Medworth Energy from Waste Combined Heat and Power Facility

PINS ref. EN010110
Revision: 1.0
June 2023

Non-Statutory Consultation Proposed Changes Statement of Purposes

Figure 2.1 Additional areas of existing and future public highway for Change 1

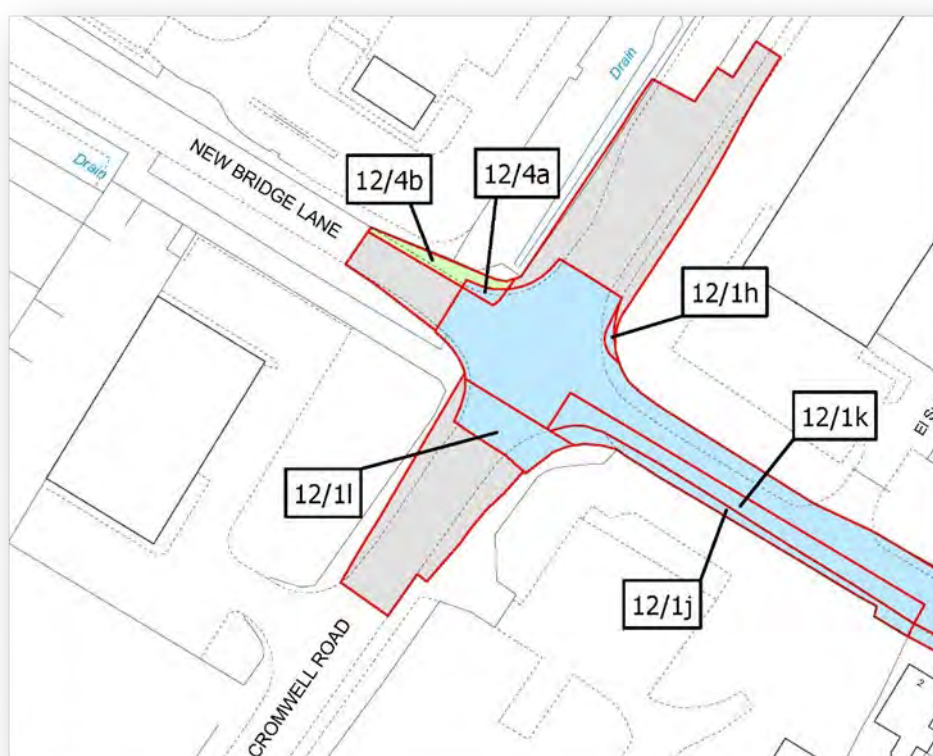
- 2.1.8 In order to facilitate the Cromwell Road Junction Signal Scheme, the Applicant proposes to extend the Order limits to include additional areas of the existing and future public highway. In respect of the existing public highway, as the Applicant will only be undertaking highway works pursuant to Article 11 of the draft DCO [\[AS-024\]](#) in these additional areas, no compulsory acquisition powers are required over these additional areas.

- 2.1.10 The additional areas of existing and future public highway are shown in grey (being existing public highway) and green (being future public highway over which temporary possession powers are being sought), in **Figure 2.1** Additional areas of existing and future public highway for Change 1.

Figure 2.2 Additional areas of existing public highway for Change 2

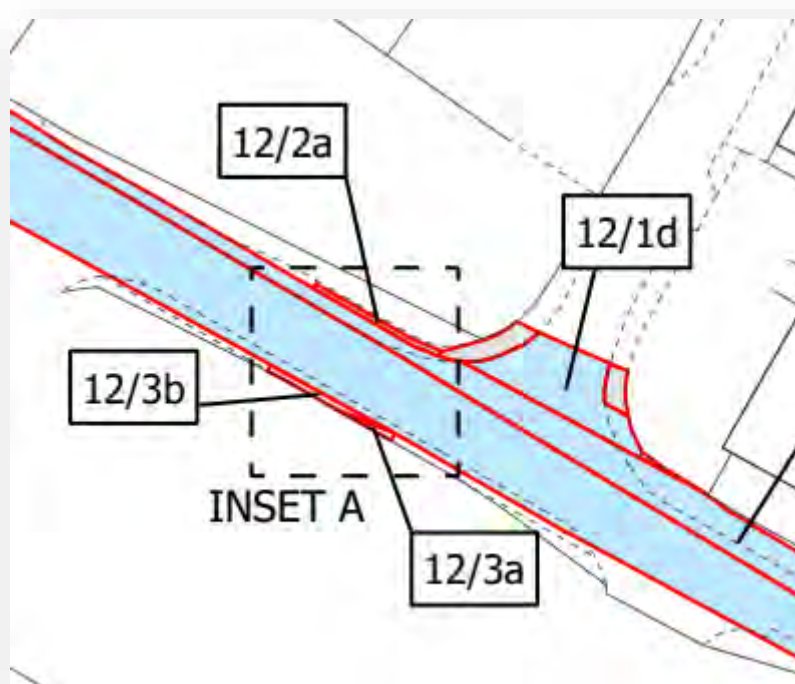
- 2.1.13 In order to facilitate the Salters Way Junction Pavement Works, the Applicant proposes to extend the Order limits to include additional areas of the existing public highway. As the Applicant will only be undertaking highway works to the existing public highway pursuant to Article 11 of the draft DCO [\[AS-024\]](#) in these additional areas, no compulsory acquisition powers are required over these additional areas. The Applicant does not require any additional temporary possession powers to carry out the Salters Way Junction Pavement Works as the pavement forms part of the existing public highway.

- 2.1.15 The land identified in grey on **Figure 2.2** Additional areas of existing public highway for Change 2 below shows the additional area of existing public highway included in the revised Order limits.

Change Addendum
Figure 3.19.iii Rev1A Cromwell Road/New
Bridge Lane Signal Scheme - General
Arrangement

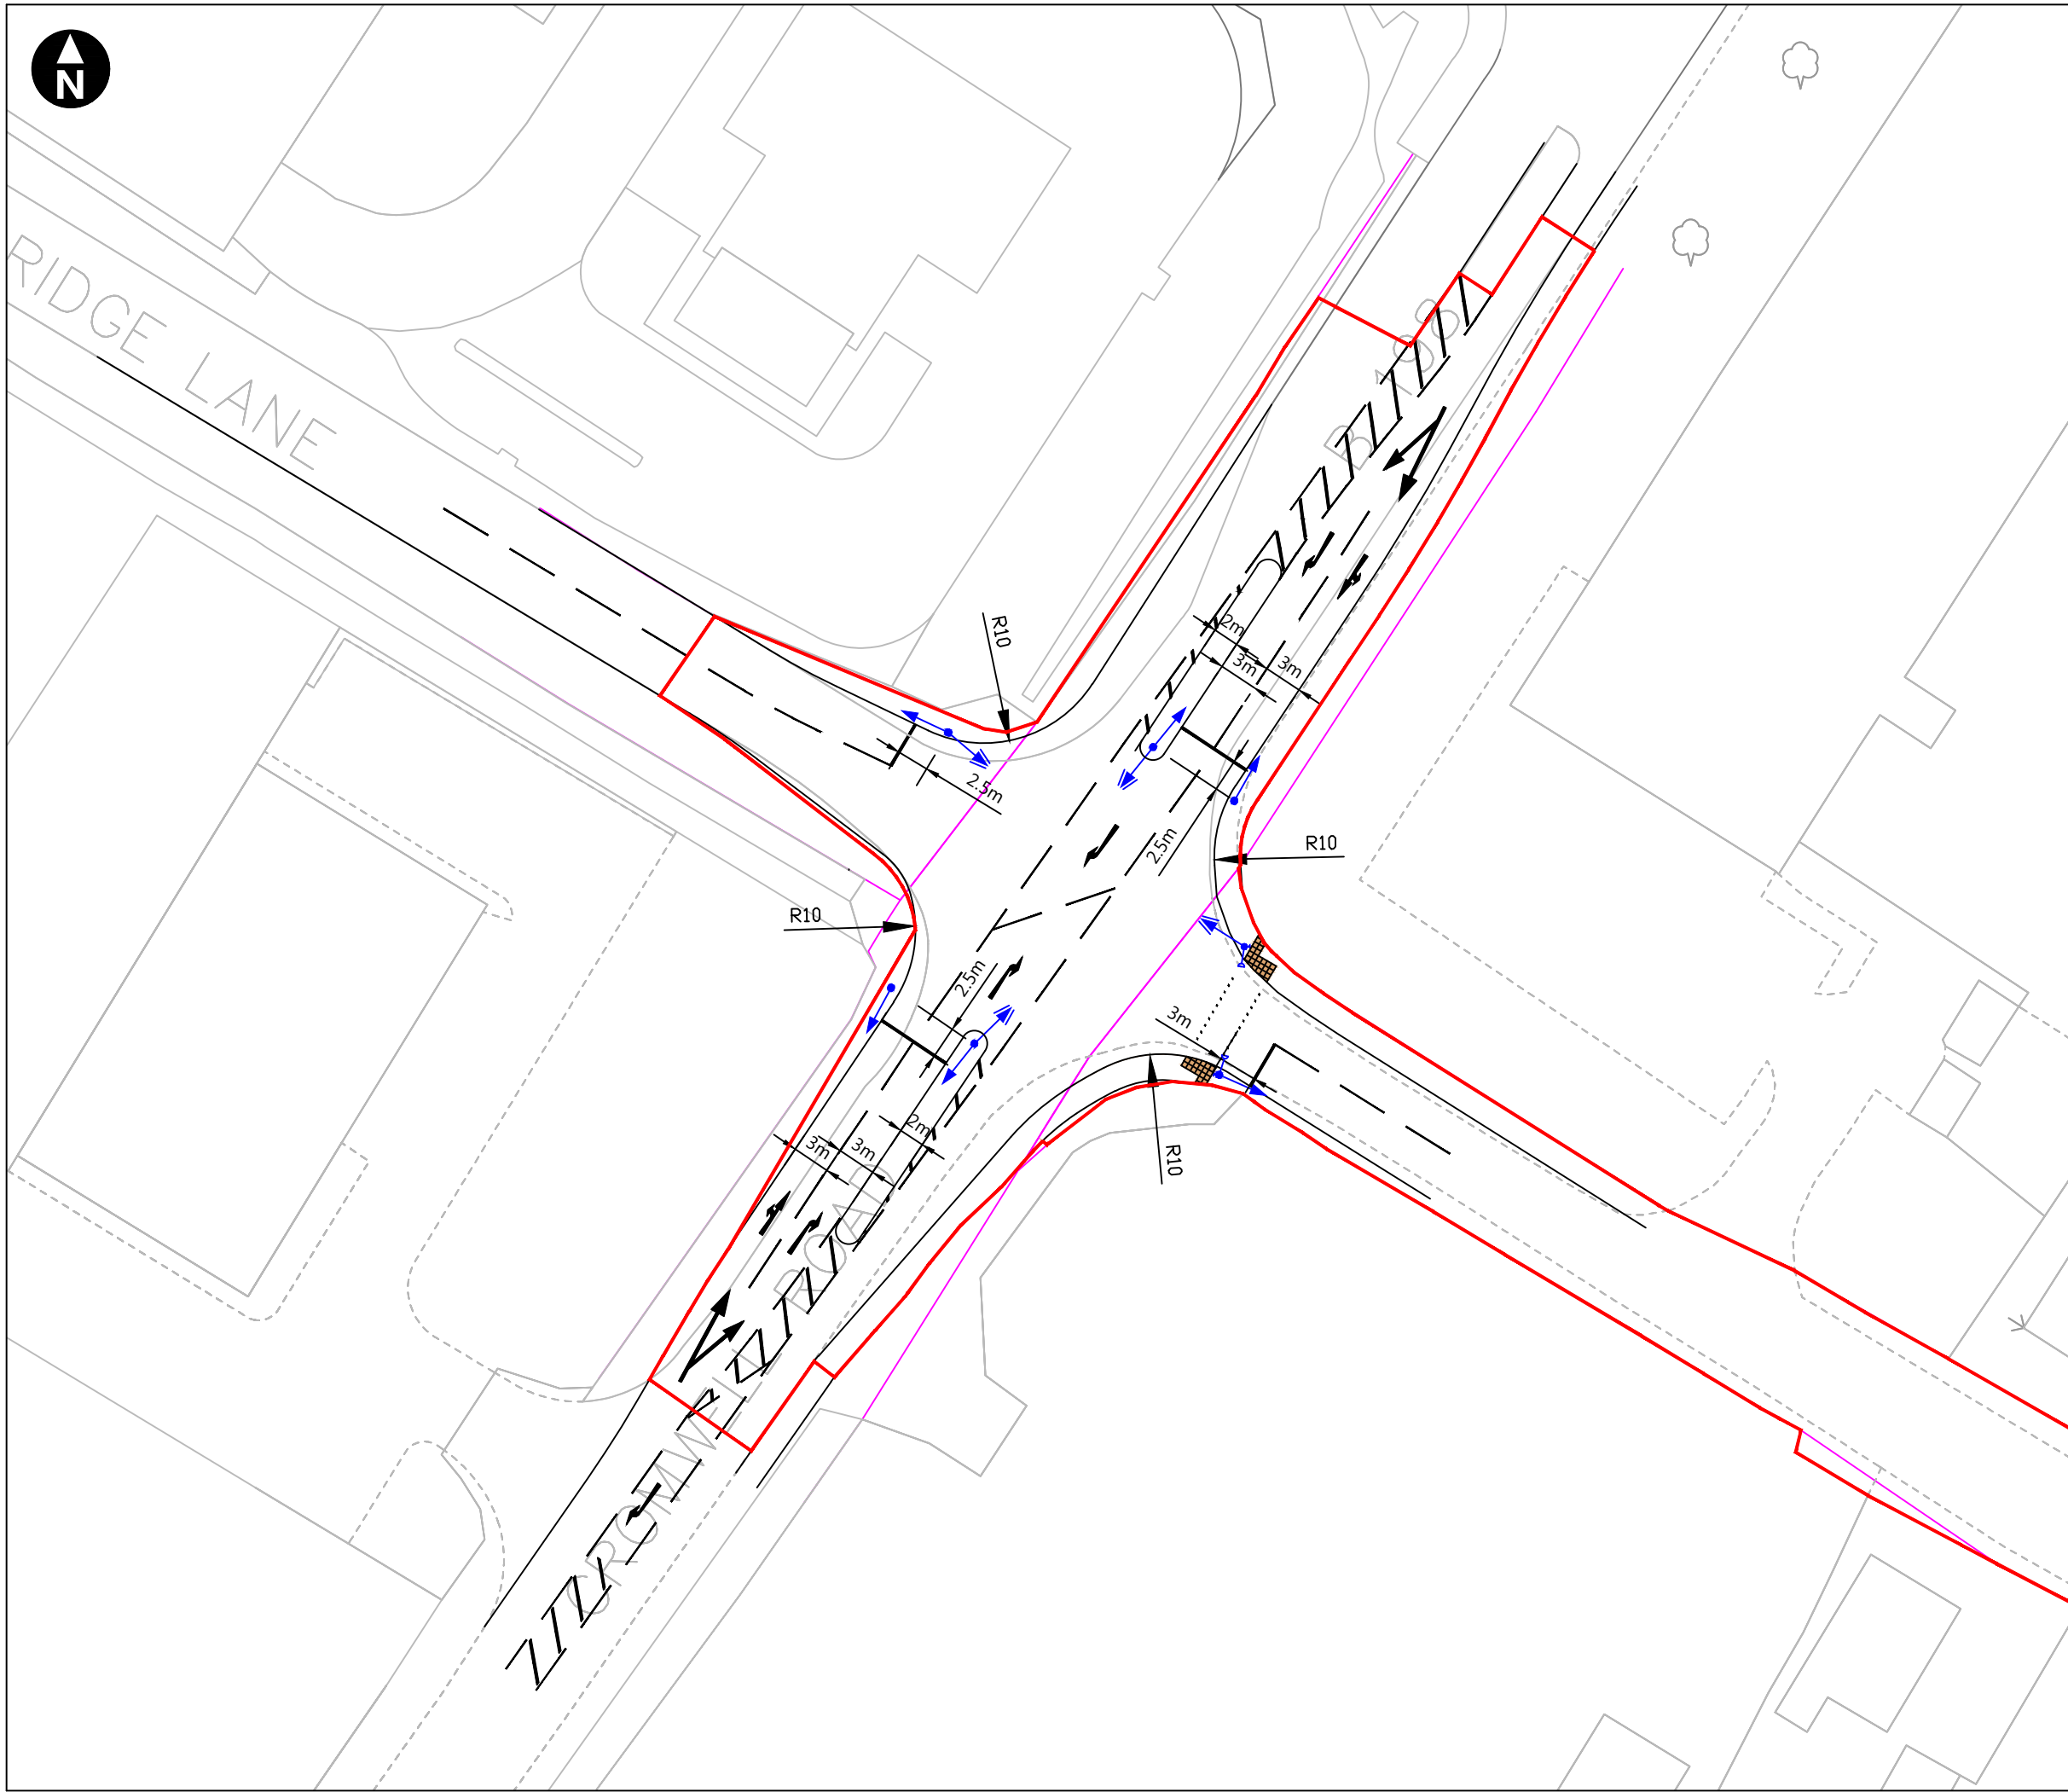
- 2.1.2 The Proposed Development includes a signal scheme at the Cromwell Road and New Bridge Lane Junction. The Cromwell Road Junction Signal Scheme will include:

- Provision of stop lines and primary and secondary traffic signal columns on all arms of the junction;
 - Realignment of the kerbs throughout the junction to accommodate additional lanes and the swept path of anticipated HGV movements.

- Provision of islands within the junction to accommodate the new traffic signal equipment.
 - Provision of signalised right turns on the B198 Cromwell Road North and South arms with right turn only lanes and right turn road markings mid junction.

- Provision of a signalised pedestrian crossing over New Bridge Lane East arm.
 - Provision of all necessary road markings to ensure clear guidance to vehicles.

- 2.1.3 A plan showing the general arrangement of the Cromwell Road Junction Signal Scheme is included in Appendix A, which is also included as Figure 3.19iii in Appendix C to the Change Report [\[AS-028\]](#).

**Change Addendum
Figure 3.19i Rev1A
New Bridge Lane access proposal**

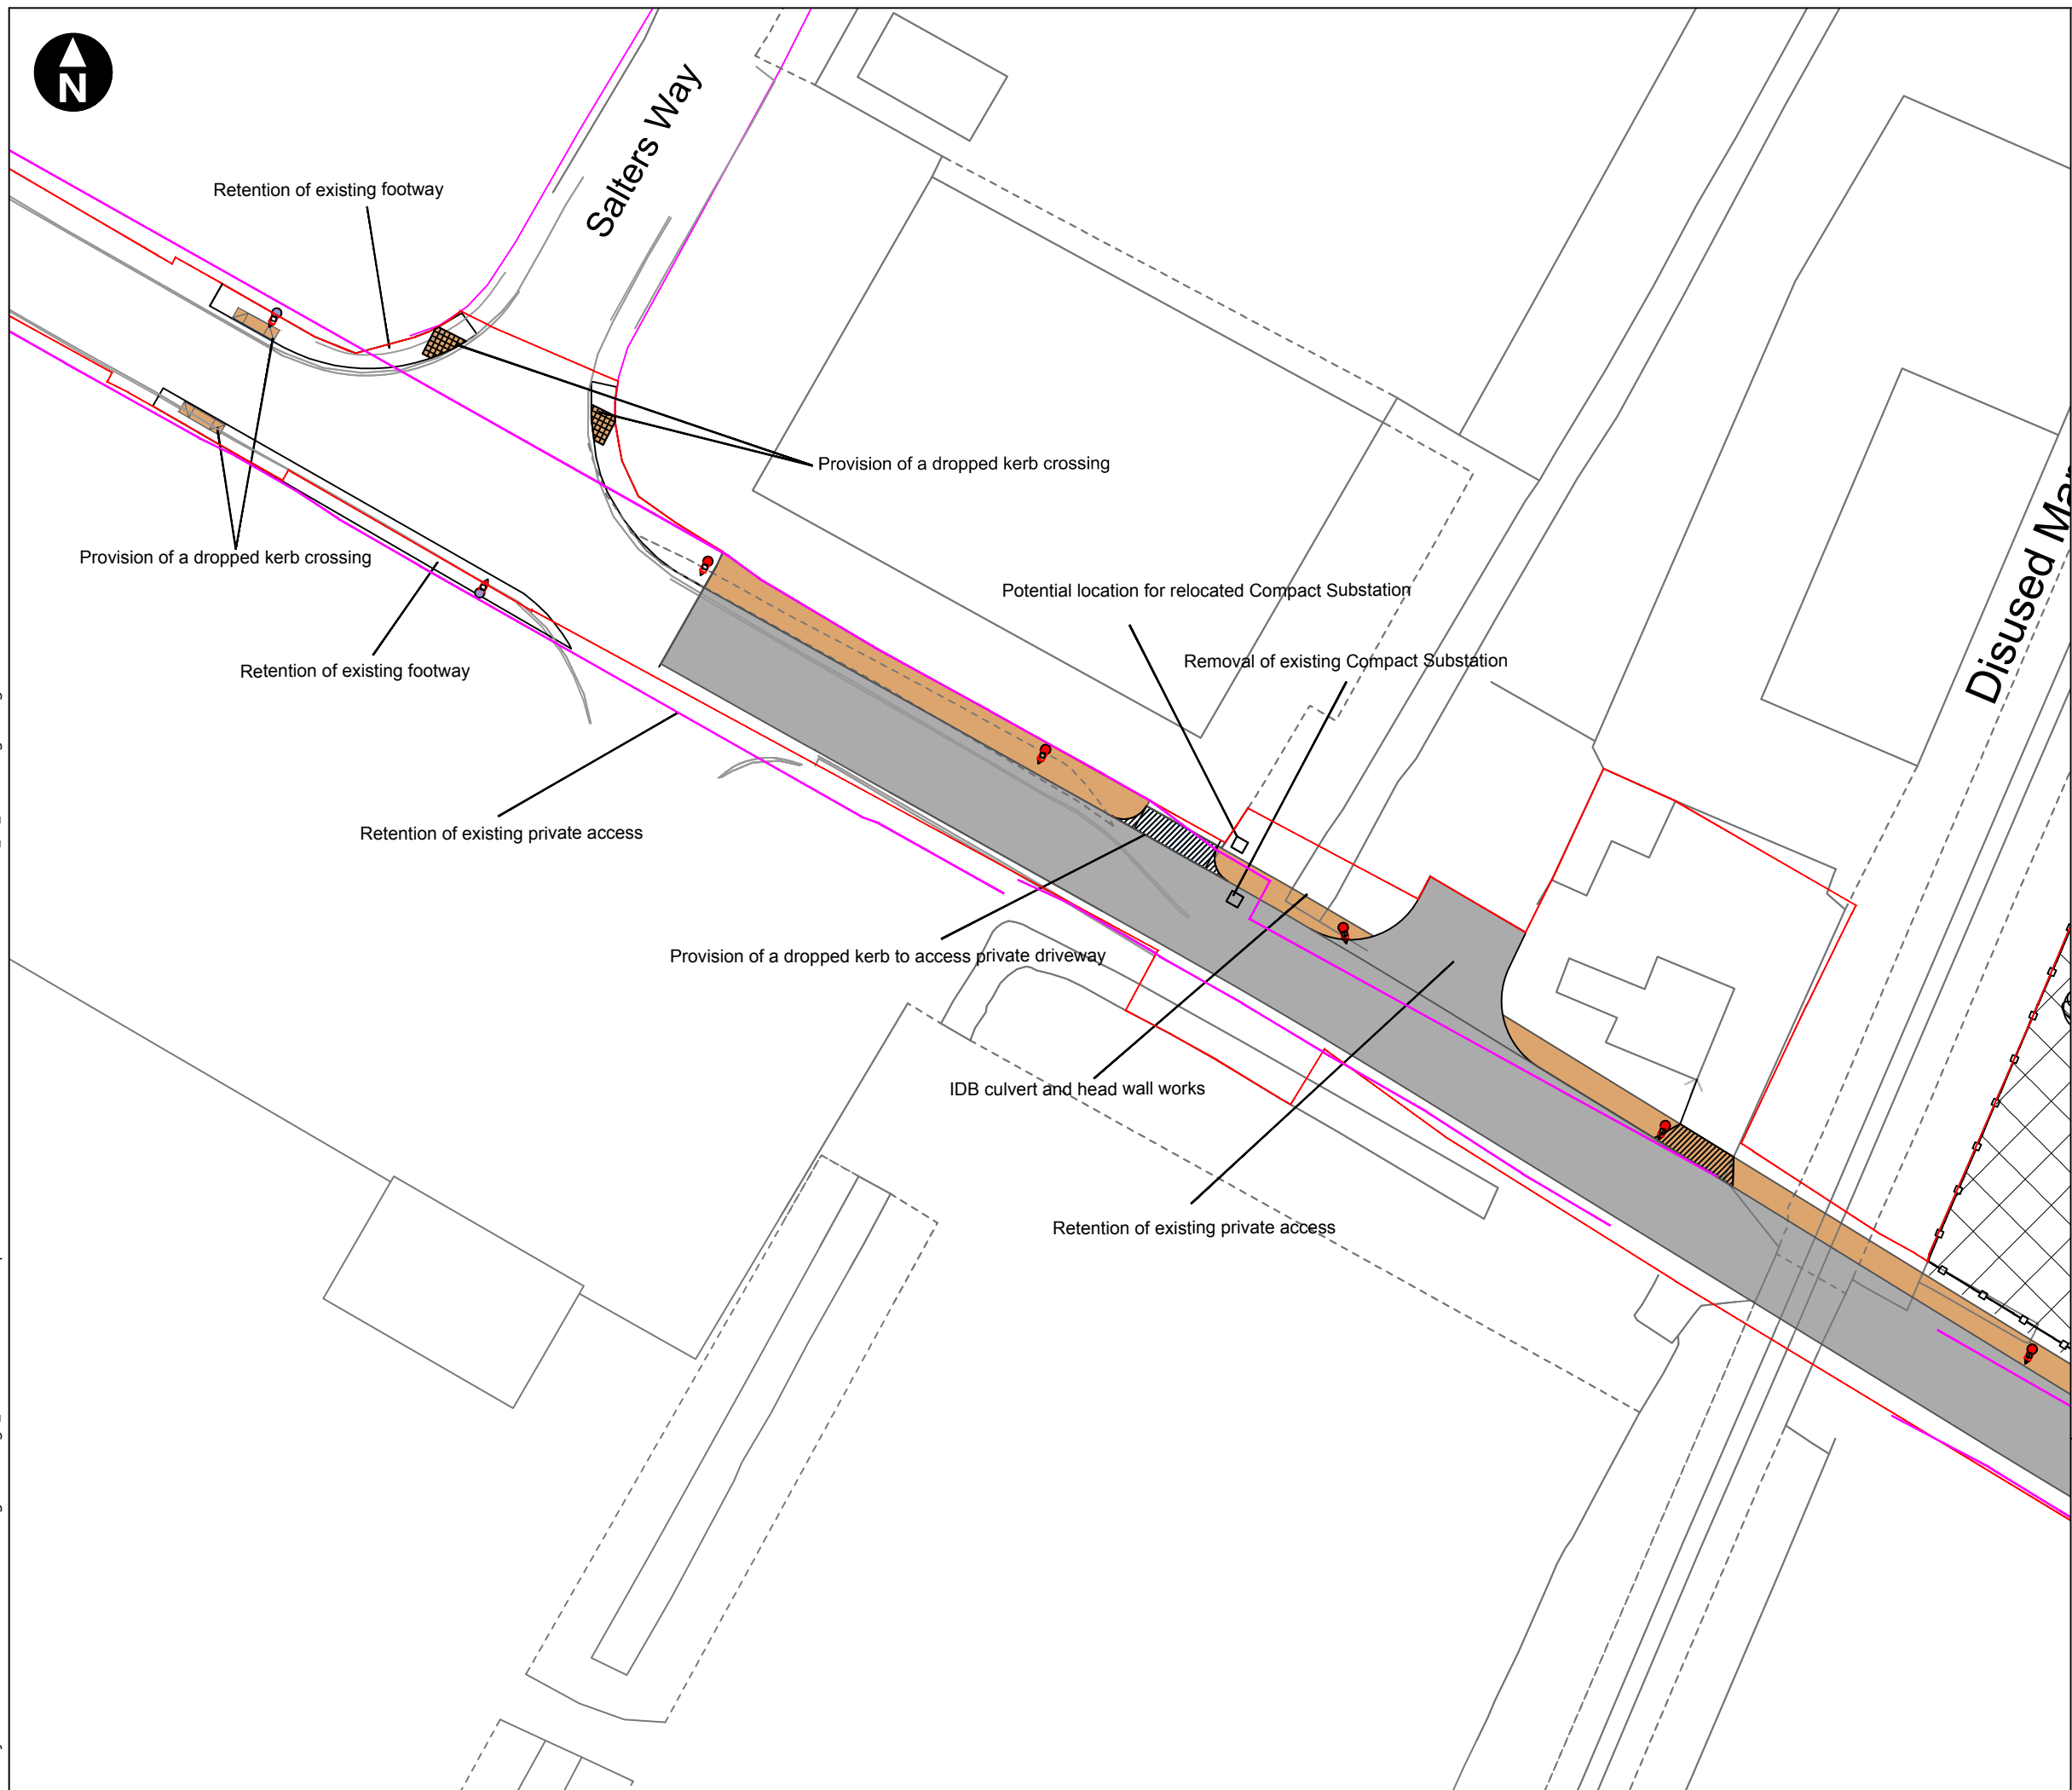
- 2.1.12 The Salters Way Junction Pavement Works consist of improvement works in the form of a dropped kerb crossing with tactile paving which is planned for the southern end of Salters Way for the benefit of pedestrians and other non-motorised users. These works will be located within the existing footpath and will provide a formal point of crossing for the benefit of all pedestrians but particularly those with pushchairs, wheelchairs or with restricted vision.

- 2.1.14 The Salters Way Junction Pavement Works are shown in Appendix B, which is also included as Figure 3.19i REV1A New Bridge Lane Access Proposals in Appendix C to the Change Report [\[AS-028\]](#).
